TSG-RAN Working Group 1 meeting #11
 San Diego, CA, USA
 February 29 – March 3, 2000

TSGR1#11(00)0326

Source: Ericsson
Title: Proposed updates to TR 25.926
Document for: Decision

This contribution proposes some updates to the TR 25.926 “UE Radio Access Capabilities”.

Figure 2: UE transport channel processing limitations in uplink

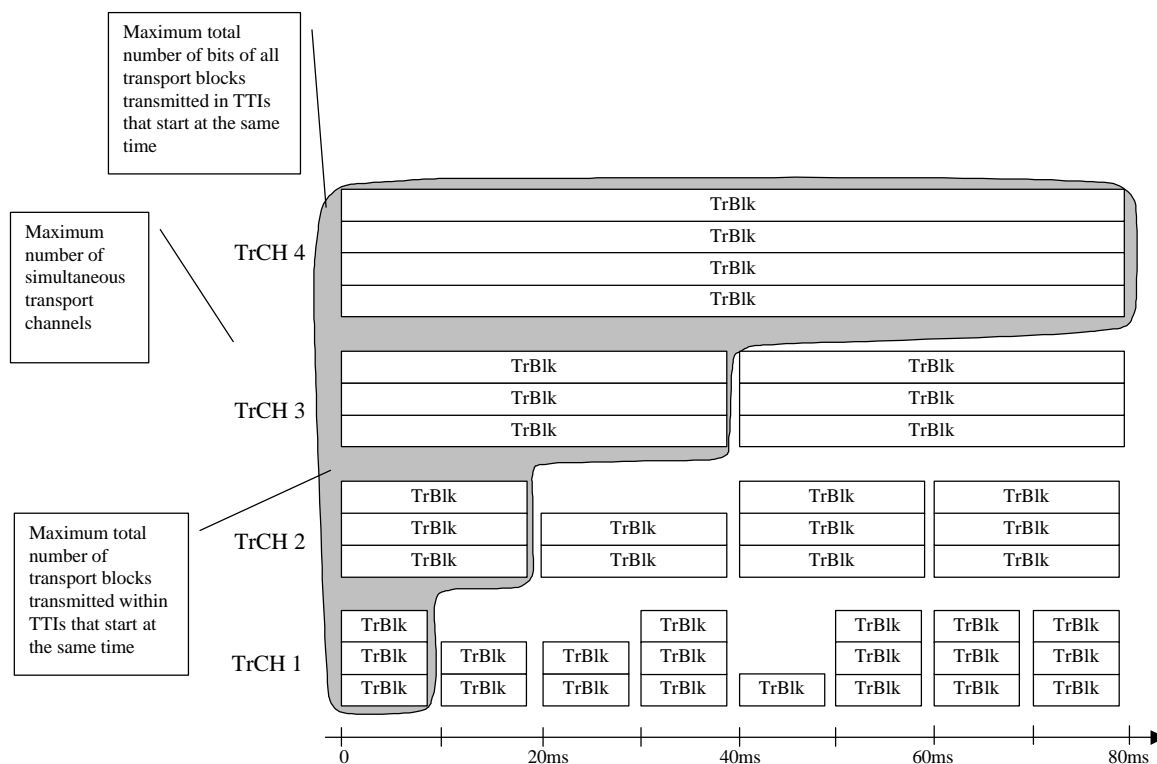
Maximum sum of number of bits of all transport blocks transmitted in TTIs that start at the same time

This parameter is related to memory requirements for uplink data received from MAC before it can be transmitted over the radio interface. As shown in Figure 2 the worst case occurs for the maximum TTI.

Maximum sum of number of bits of all convolutionally coded transport blocks transmitted in TTIs that start at the same time

Maximum sum of number of bits of all turbo coded transport blocks transmitted in TTIs that start at the same time
